DH/AC
15756
15 July 2016

**ADDITIONAL CLARIFICATIONS
AUSTRALIAN TECHNOLOGY PARK, EVELEIGH**

Figure 1 – Public access easement, as shown highlighted in green

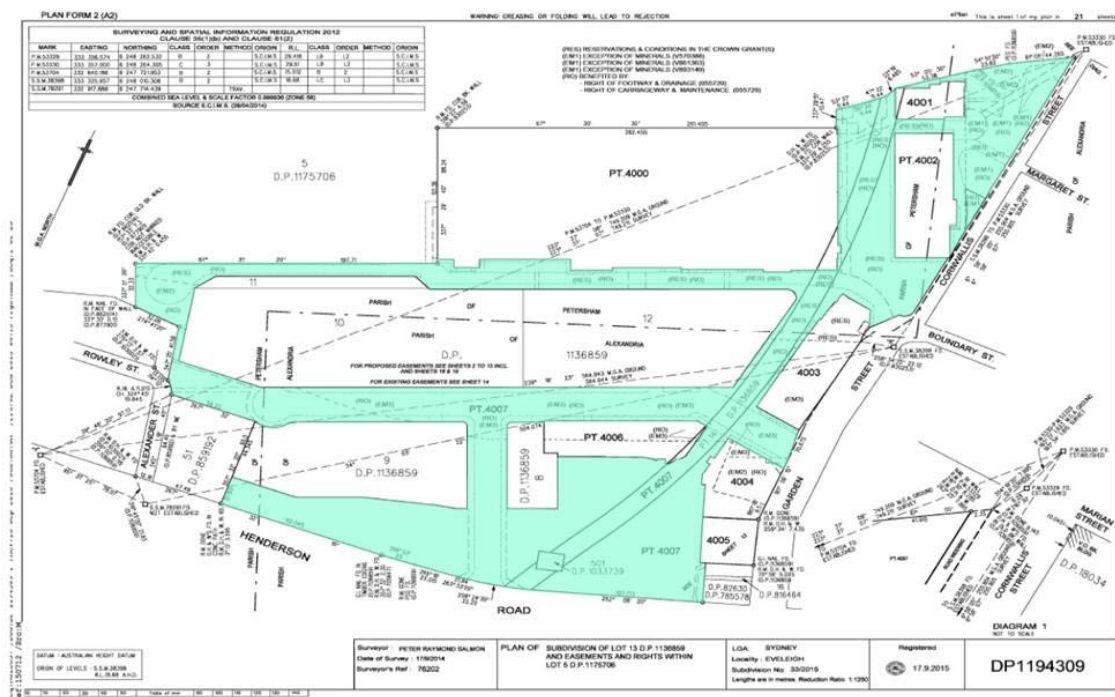
6. Could you confirm whether there is a public access easement over Central Plaza?

Response: The public access easement pertains only to Lot 4007, i.e. that land coloured blue in the below subdivision plan (**Figure 1**). The Village Square (Central Plaza) forms part of Lot 10 of Deposited Plan 1136859 which is under the ownership of Centuria. As evident from the below plan for Media City/Chanel 7 (**Figure 2**), this plaza area includes car parking below and therefore logically does not form part of the public domain lot – for which public access is secured through an easement.

Whilst there is not a formal public access easement in place at present, Centuria as the owner of Lot 10 has agreed to grant an easement over the plaza area, for amongst other things, access, passive recreation and fire egress. This easement will be in place prior to occupation of the new building on Lot 12.

The terms of the access easement includes a full, free and unimpeded right to enter the Village Square for the purpose of passive recreation and thoroughfare and other associated uses and to remain upon and pass and repass to, from and across the Village Square at all times.

Figure 3 – Original Redfern Waterloo Sites FSR Map

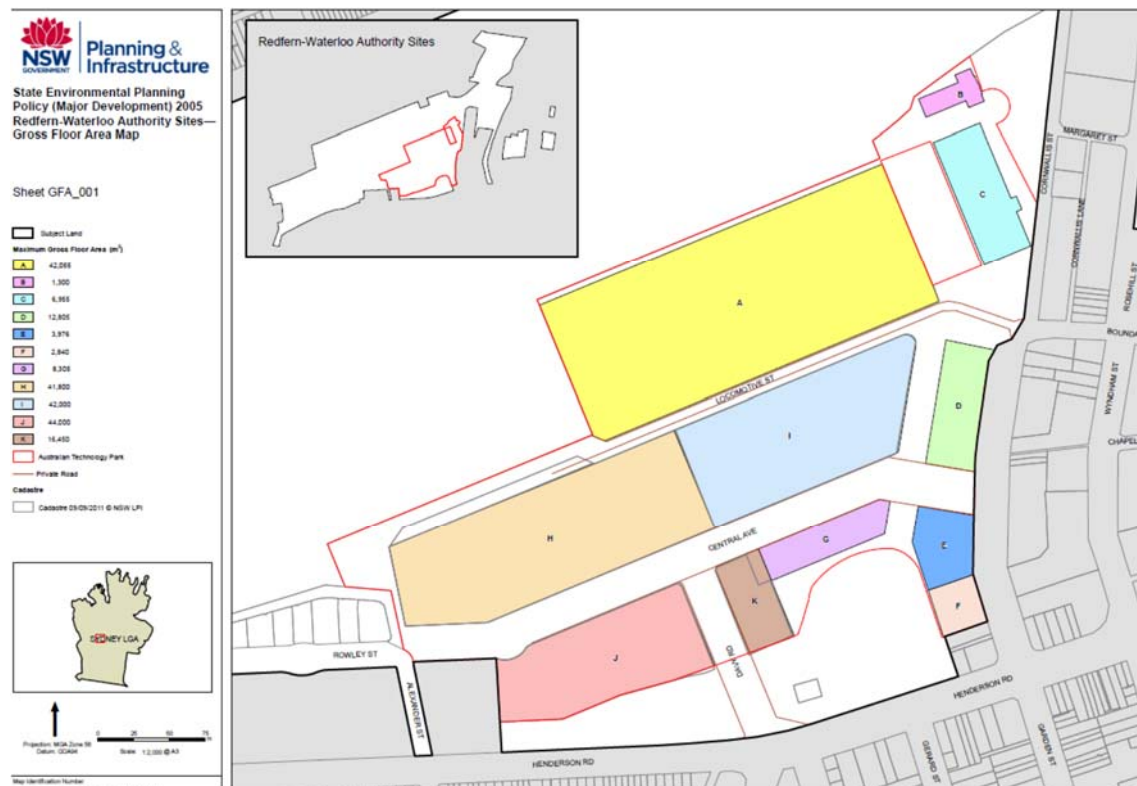
7. Could you provide additional information in relation to the overall FSR of the ATP – see the note under Clause 21(2A) of Part 5 of the SSP SEPP?

Response: A review of the history/background to this note reveals that the original floor space control within the Major Development SEPP for the Redfern-Waterloo Sites was achieved through traditional maximum FSR provisions, this included a maximum FSR of 2:1 for ATP. Refer to **Figure 3** below of the original SEPP FSR Map. An amendment to the Major Development SEPP was subsequently made (refer to **Figure 4**), whereby the site wide approach to FSR was converted to a specific development lot site maximum GFA approach. It is this maximum GFA per development site approach that applies today to the subject development application and broader ATP site.
